Fuel Leak Case No. RO0002608 and GeoTracker Global ID T06019754249, Hans and

Gunter Roofing Company, 2834 E 7th Street, Oakland, CA 94601

TECHNICAL COMMENTS

Proposed Groundwater and Soil Gas Sampling Locations

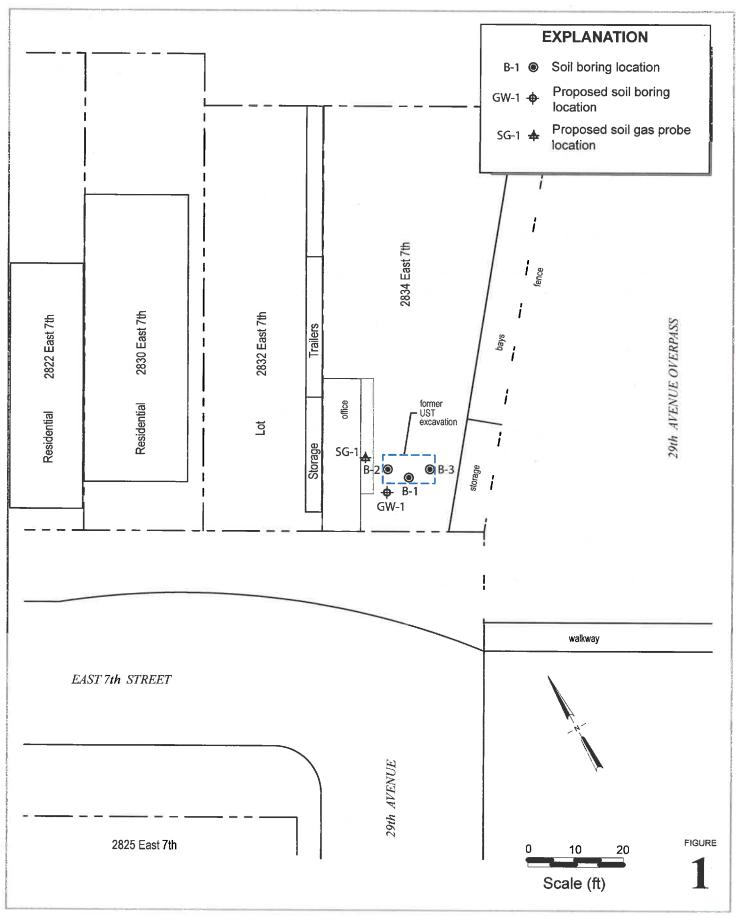
ACEH's review of the case files indicates that groundwater has not been tested for MTBE. No groundwater samples have been collected at the site. The work plan proposes MTBE analysis. Please present the results of this sampling and analysis in the SWI requested in Item 9.

No groundwater samples have been collected at the site. The work plan proposes sampling and analysis of groundwater. ACEH recommends installing a temporary casing to ensure that the boring remains open overnight. Use of a sand pack is not necessary. In addition to collecting a groundwater sample from the boring, please collect soil samples from the zero to five and five to ten foot intervals for total petroleum hydrocarbons as gasoline (TPHg), benzene, toluene, ethylbenzene, xylenes (BTEX), methyl tertiary butyl alcohol (MTBE), di-isopropyl ether (DIPE), ethyl tertiary butyl ether (ETBE), tertiary amyl methyl ether (TAME), 1, 2-dicholoroethane (EDC), ethylene dibromide (EDB), and naphthalene. These analyses will assist in the Low-Threat Closure Policy review for the site. Please present the results of this sampling and analysis in the SWI requested in Item 9.

Figure 1. Soil Vapor Sampling Manifold Schematic

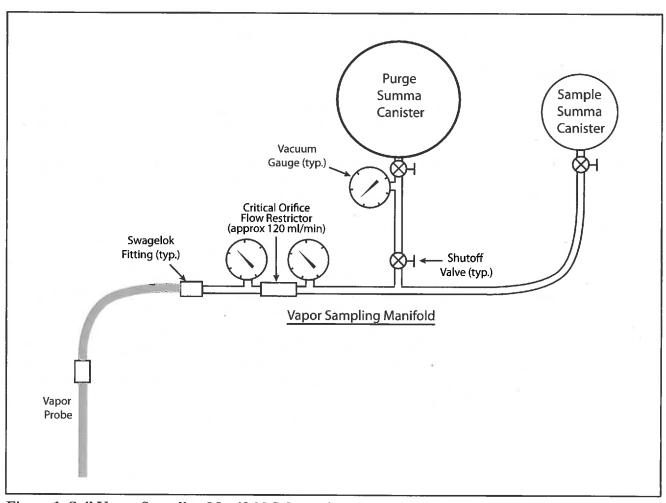
- 7. Soil Vapor Sampling Protocols The vapor sampling protocols that are referenced are the 2005 Department of Toxic Substance Control's guidance not the most recent DTSC guidance. Please ensure that soil vapor samples are collected in accordance with the April 2012 Advisory Active Soil Gas Investigations. ACEH's review of the work plan indicates that at a minimum, Pangea's standard operating procedures (SOPs) vary from this document in the following aspects:

- The recommended confirmation sampling method for naphthalene is EPA Method TO-17. If Pangea analyzes soil vapor samples using TO-15 rather than TO-17, than please provide Pangea's SOPs for confirmation sampling using TO-17. Ensure that confirmation sampling is conducted.

Please provide revised soil vapor SOPs in a brief work plan addendum described in Item 8 below.
